LOUISIANA
POWER & LIGHT

SUBJECT: Waterford SES Unit 3
Docket No. 50-382
Auxiliary Pressurizer Spray (APS)

WATERFORD 3
Justification for Interim Operation
Auxiliary Pressurizer Spray

FIGURE 1

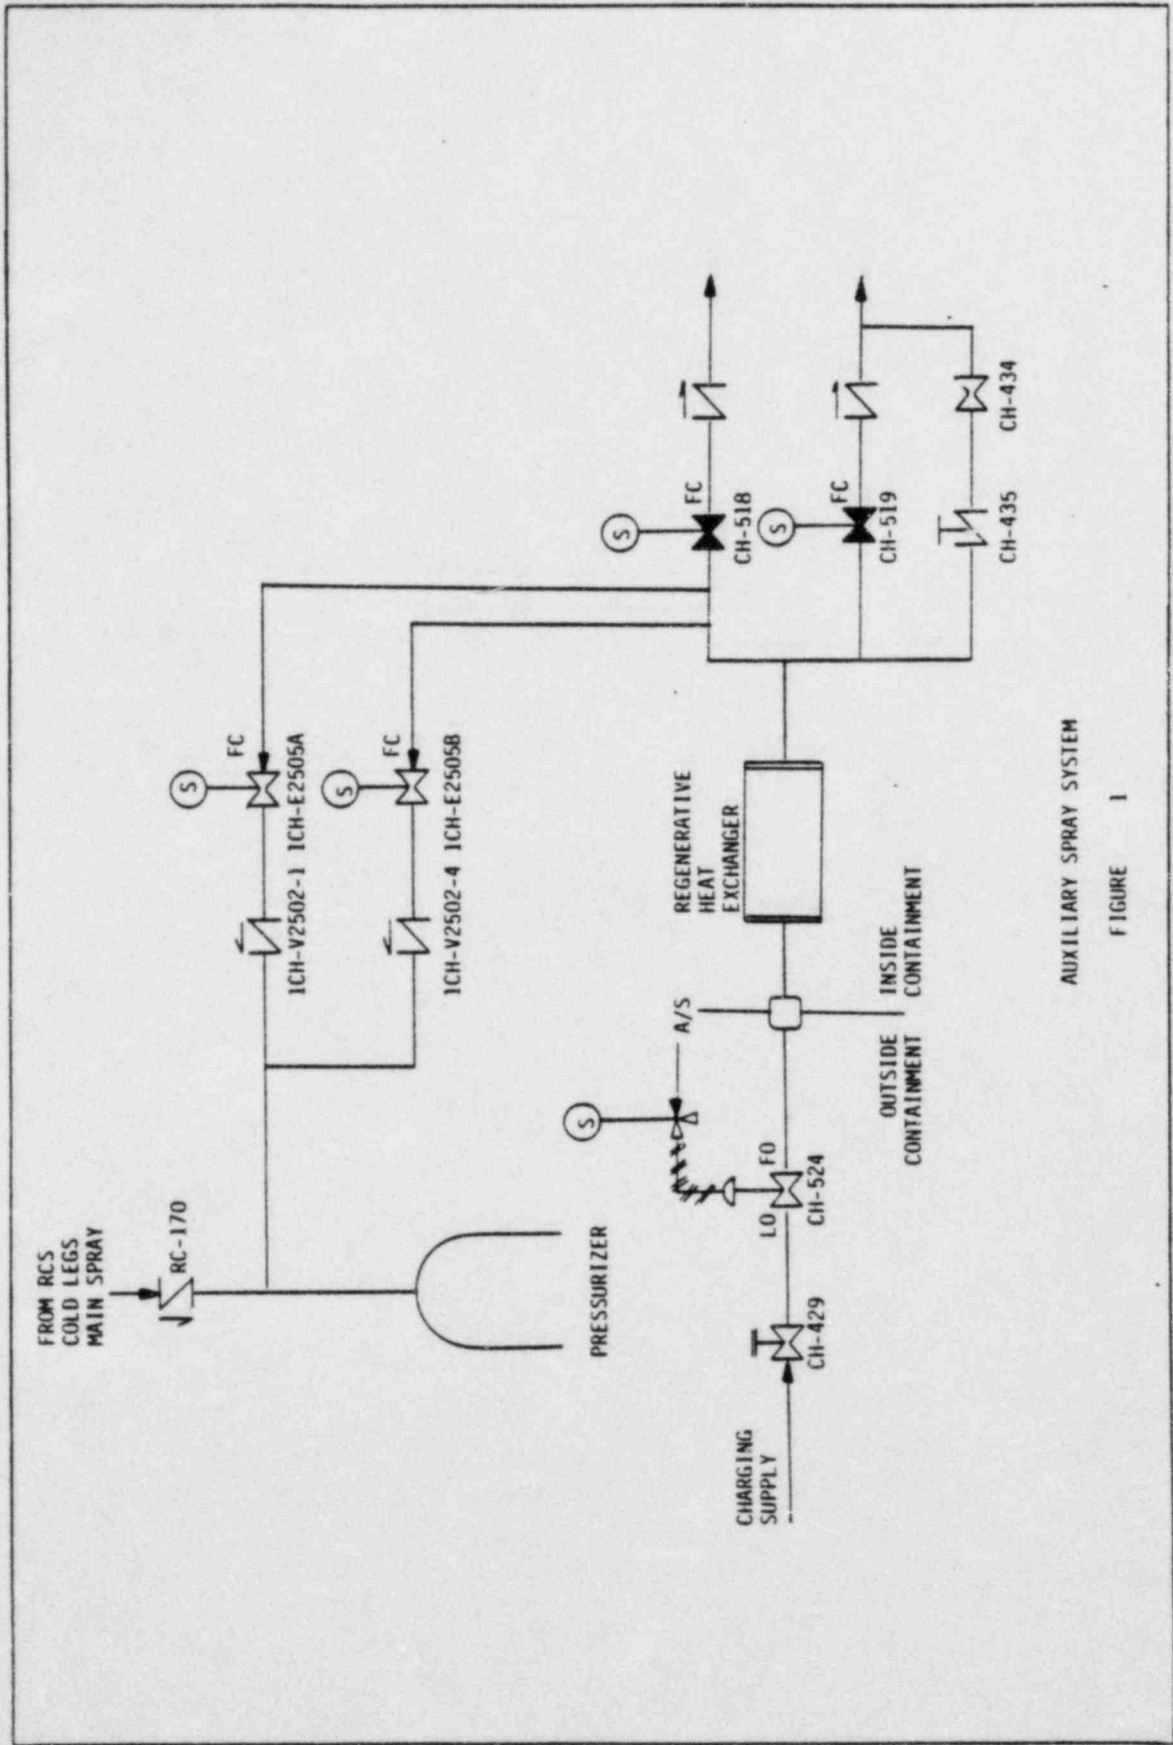
The NRC has expressed a concern that the APS depressurization may potentially be defeated if one of the two charging line isolation valves (CH-518 or CH-519, see Figure 1) fail to close. This will cause a diversion of flow from the pressurizer spray nozzle and a reduced depressurization rate. Justification for safe full power operation of Waterford 3 prior to final resolution of this concern is based on the following considerations:

The charging line isolation valves (CH-518 and CH-519 in the attached figure) are solenoid valves controlled by the operator from the control room. The failure probability of these valves has been evaluated in CEN-239, Supplement 2, "Probabalistic Risk Assessment of the Effect of PORVs on depressurization and Decay Heat Removal", submitted to the NRC by Reference 1. The probability for either charging line isolation valve to fail to close due to a mechanical malfunction is approximately $2.3E-3$. Thus the probability that the effectiveness of the APS will be reduced because these valves fail to close is very low.

Finally, preliminary calculations have been performed to calculate the flow delivered to the pressurizer spray nozzles with an open charging line isolation valve. These calculations account for the hydraulic resistance and elevation differences in each flow path (charging and spray) to determine the percent flow split between the two paths. Based on these preliminary calculations, one-quarter of the APS flow achieved with both charging valves closed goes to the pressurizer spray nozzles. Although this would result in a reduced depressurization rate relative to the full APS flow capability, it should be sufficient to mitigate the consequences of a SGTR.

and throttling HPSI pumps) to depressurize the RCS during a SGTR while maintaining subcooling margin requirements, and preliminary calculations which show that a portion of the flow (one-quarter of the APS flow with no failure) reaches the pressurizer spray nozzles even if a charging line isolation valve fails to close.
